CITY COUNCIL AGENDA ITEM

AGENDA ITEM: **RZ10-007/CV10-008** - 5600 Roswell Road (SR 9), *Applicant:*
Prado LLC, To rezone the subject property from C-1 conditional to
C-1 to add 15,000 square feet to the existing approved square
footage for the shopping center, with concurrent variances

Agenda Item: **RZ10-007/CV10-010 5600 Roswell Road**, Request to rezone from C-1 (Community Business District) conditional to C-1 (Community Business District) conditional, with concurrent variances, to add 15,000 square feet to the existing approved square footage for the shopping center.

Front Elevation (east)

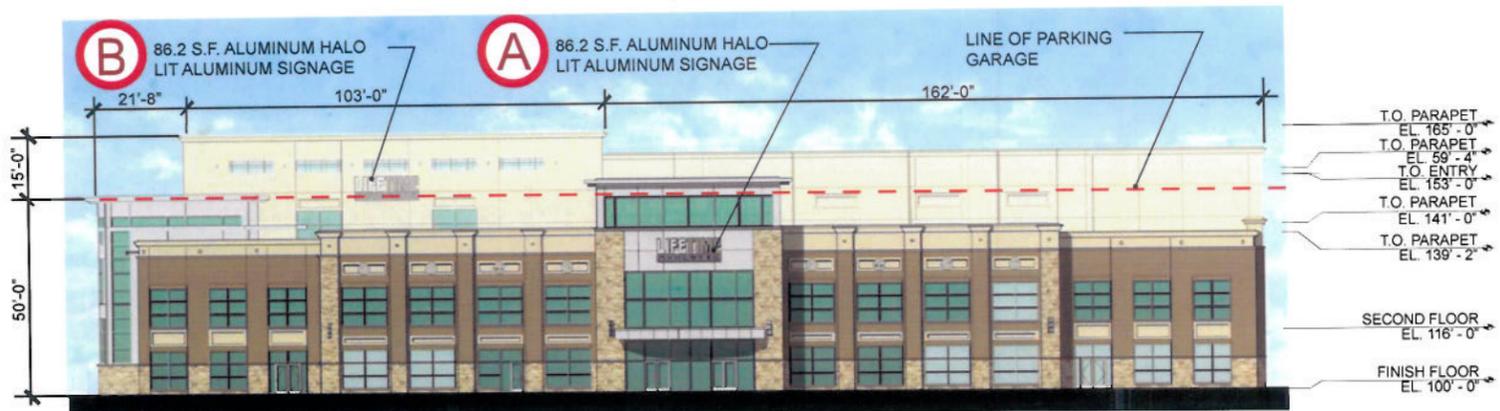
The applicant proposes to install two (2) wall signs on the east elevation of the building. The east elevation is not a street facing wall; therefore signs on this wall require a variance. The proposed wall signs on the East elevation of the building are intended to provide visibility to Anchor B from all levels of the parking deck. Anchor Pad B is located approximately 50 feet lower than the finished floor of the adjacent Target building and the parking deck and approximately 15 feet below the Prado Place finished grade which is the main Street to the development. One wall sign is to be placed over an entrance portal where it will be readily seen from the interior of the parking structure. In addition, the applicant proposes to locate an additional wall sign at the upper corner of the east elevation which will be seen from the upper deck of the parking structure. The total proposed wall sign area for both signs on the east elevation is approximately 172.4 square feet and the signs will be halo lit. The east elevation contains a total of approximately 17,390.3 square feet. The ordinance allows 5% of the total wall area, or 180 square feet maximum.

- u. Variance from Section 33.26.H.2.a. of the Zoning Ordinance to allow two (2) wall signs to be located on a non-street facing wall which is the east elevation of the building to be built upon Anchor B Pad. All signs shall be installed substantially in accordance with signs shown in the sign plan package, building elevation drawings, and renderings received by the Department of Community Development on August 10, 2010. (CV10-010).

Back Elevation (west)

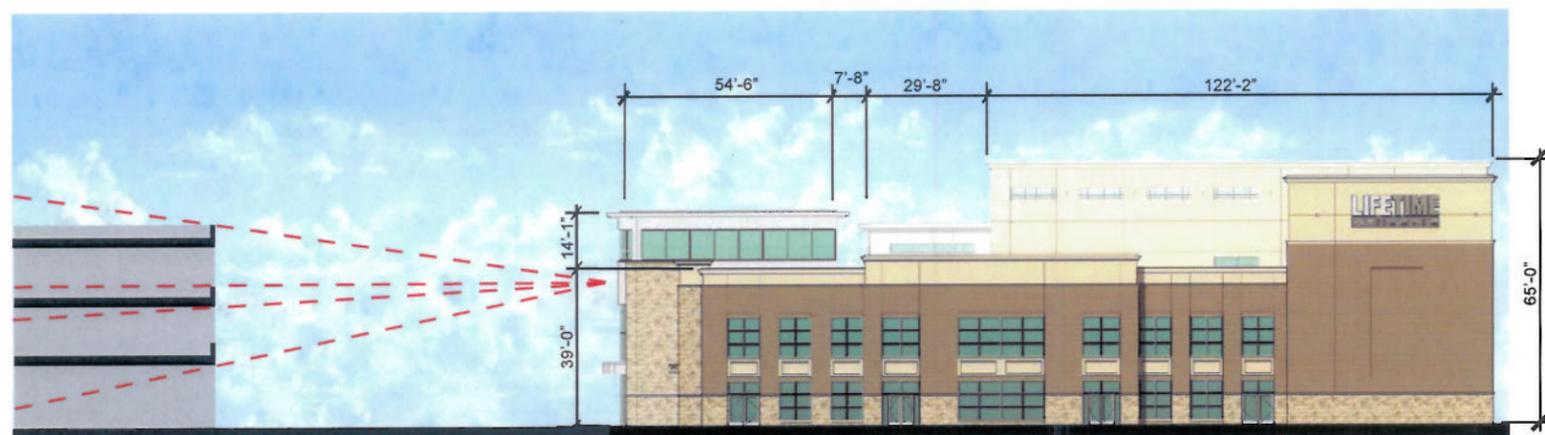
1. Rework the architecture on the west (rear) building elevation. Request to add articulation to rear elevation. Request to limit the frosted glass or Kalwall panels.

Life Time Fitness has revised the west elevation to include additional pilasters, articulation, and limestone material. Other than what is shown on the elevation drawings, the applicant has proffered that no additional frosted glass or Kalwall panels will be added to the west and south facade. The aforementioned concern(s) have been addressed in the staff recommended condition(s) 2.e.

- e. Subject to the approval of the Director of Community Development and where feasible and aesthetically pleasing for the Lifetime Fitness concept, to be in accordance with the revised western (rear) elevation drawing, received by the Department of Community Development on August 10, 2010, for Anchor B showing additional pilasters and articulation along the rear of the building having the extension of limestone material vertically along the pilasters. Additionally, the top band of glass block on the west and south elevations shall be in accordance with the building elevation drawings and renderings received by the Department of Community Development on August 10, 2010 and shall be frosted glass having a translucent wall panel (Kalwall - as seen on material board received by the Department of Community Development on August 10, 2010.). No additional frosted glass or Kalwall panels shall be added to the west and south facade.
